# CITY OF PORTLAND, MAINE

## AGENDA PORTLAND PLANNING BOARD MEETING

**To:** Maggie Stanley, Chair and Members of the Planning Board  
**From:** Austen Torres Davis, Planner  
**Date:** September 23, 2022  
**Re:** Major Site Plan Application – 31 Forest Street  
**Project #:** PL-002018-2022  
**Meeting Date:** September 27, 2022

**Subject:** Site Plan Review Comments – 31 Forest Street.

| SMRT FILE: CU101-21004 | SHEET No. CU101        |

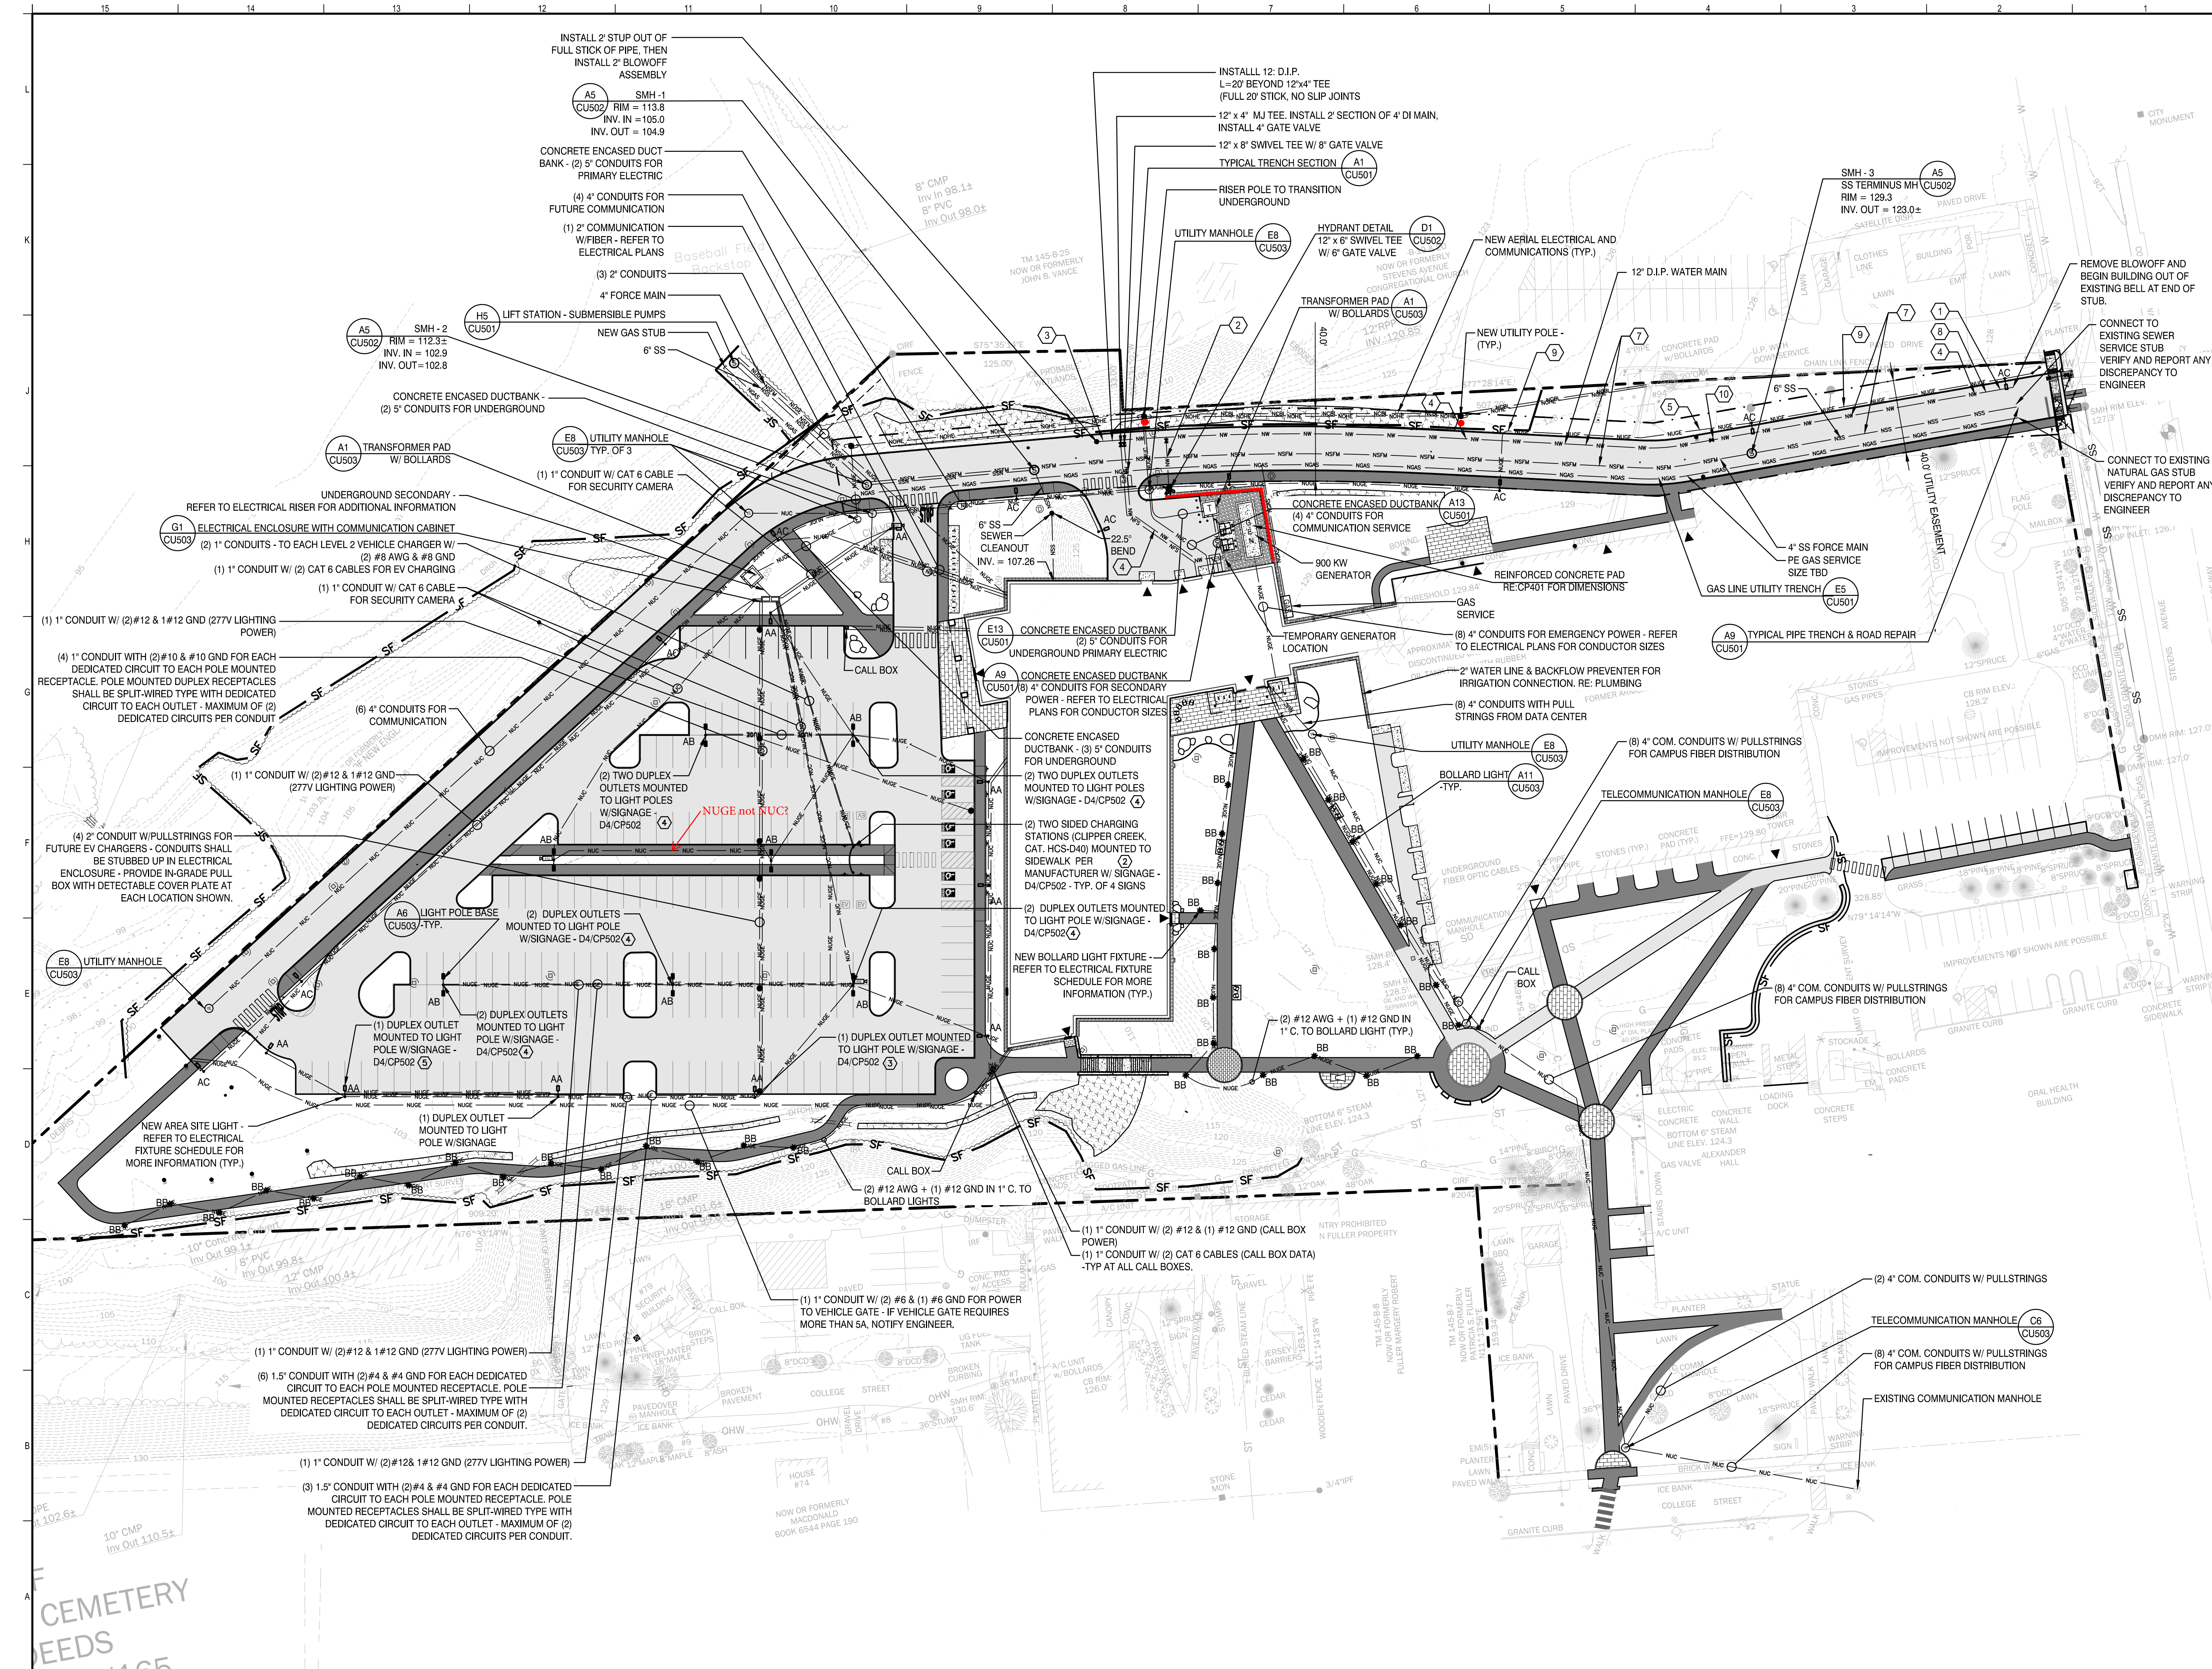
**Comment:** The board was not comfortable with waiving the EV parking requirements. We have attached a revised drawing CU101 showing 36 of the total 182 parking spaces as EV charging spaces, which is 20%, meeting the requirements of section 1.17 of the Technical Manual. Conduit pathways to each row, the transformer, below grade pull boxes, and the electrical panel will be in place to serve the remaining spaces as the need arises. Per our discussions with staff, we believe the current plan fulfills the requirements of the standard. Therefore, a waiver of this standard is not required.
